# No impact on Ground Water ?

## Seattle-Tacoma International Airport Outfall 007 (SDN 2)

Subject : Comments on DOE and Port of Seattle Agreement for Ground Water  
Study at Airport

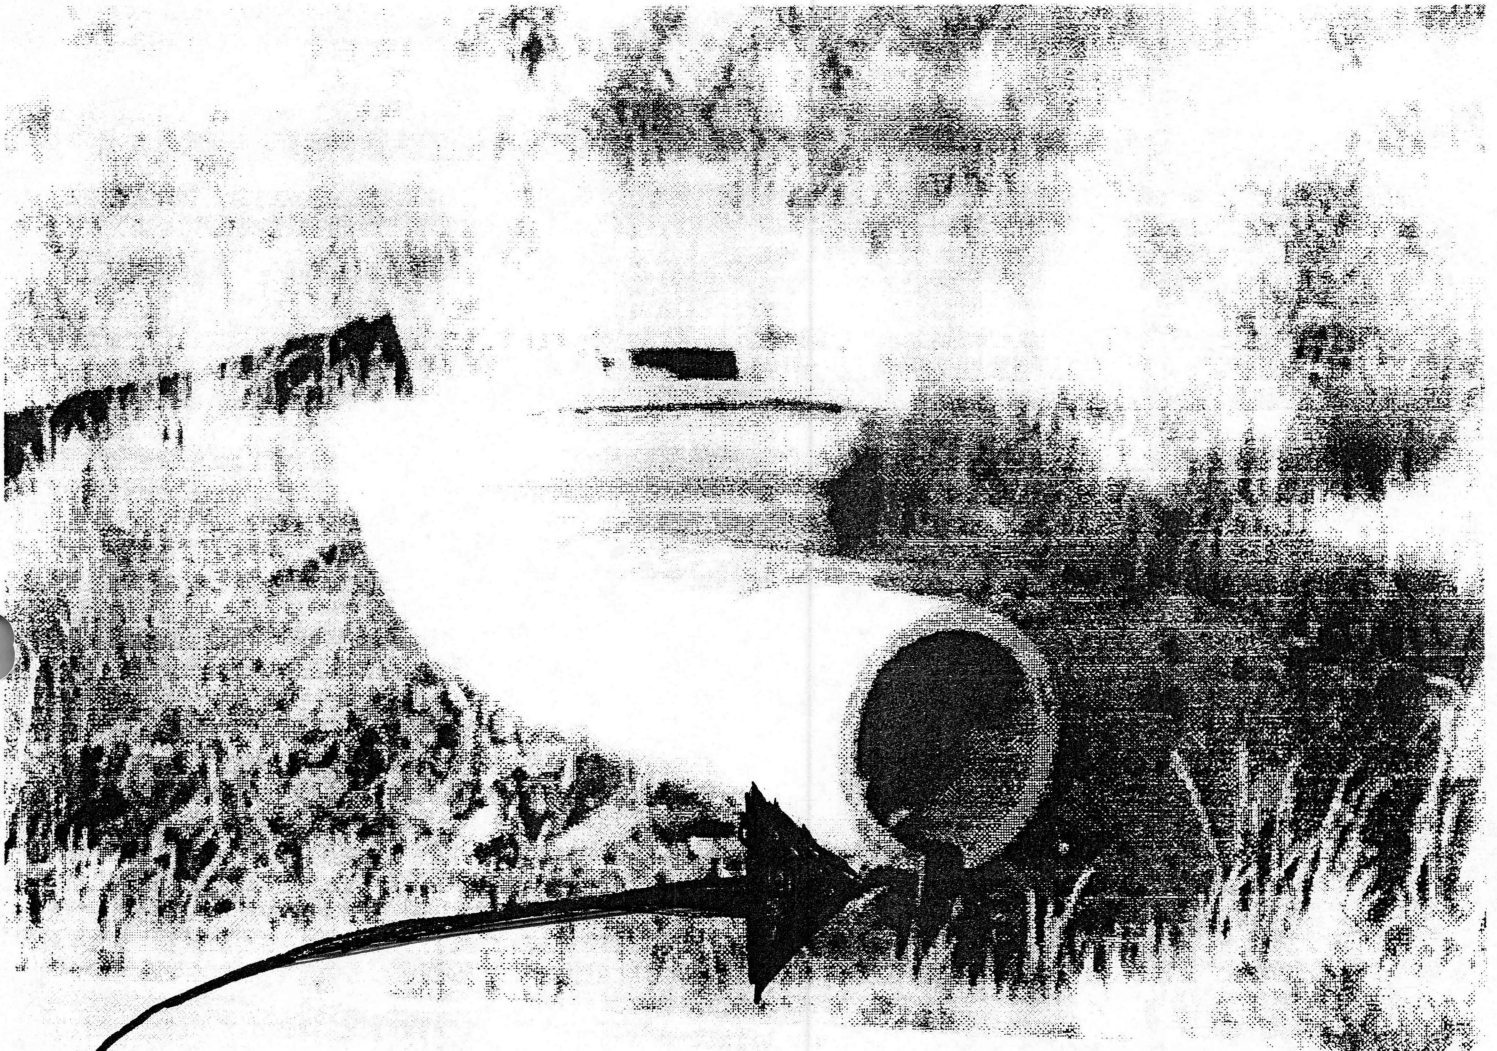
Location : Just south of well head that supplies **drinking water** to the Seattle area,

- south side of S154 St near landing light towers on north end of airport
- approximately 2000 feet southwest of Reba Detention facility

- Receiving water : **Miller Creek** via Reba Lake
- Pollutants include **grease** and **oil** as well as possibly **glycols**

The detailed study area needs to be expanded to include the fuel depot, outfalls, Lake Reba and all significant pollution sites related to the airport. How can you ignore outfalls? See photograph of oil and grease on cover.

5/20/97  
outfall '7

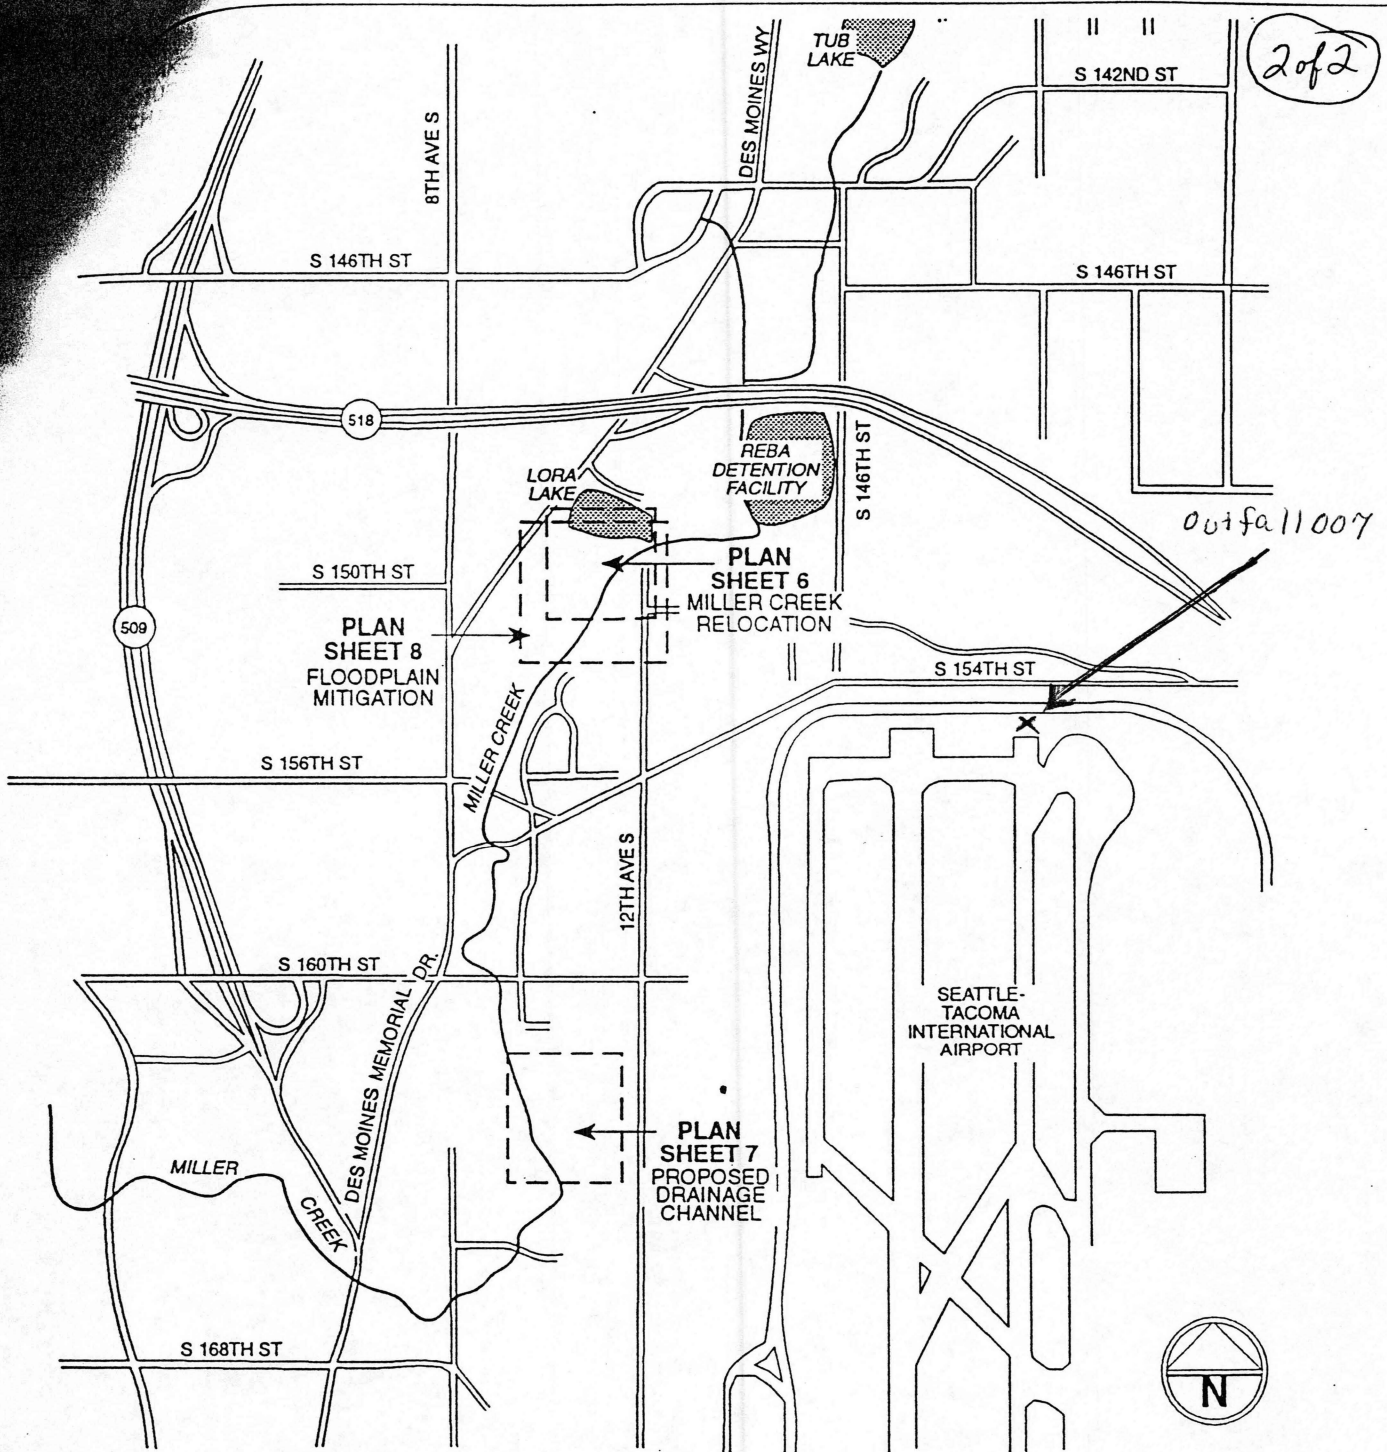
Copy of polaroid photograph passed around  
Room at Burien Library Public Meeting by  
Derek Brown on May 21, 1997. Same  
outfall as A. Brown comments but  
photographed one day later on 20 May  
1997.
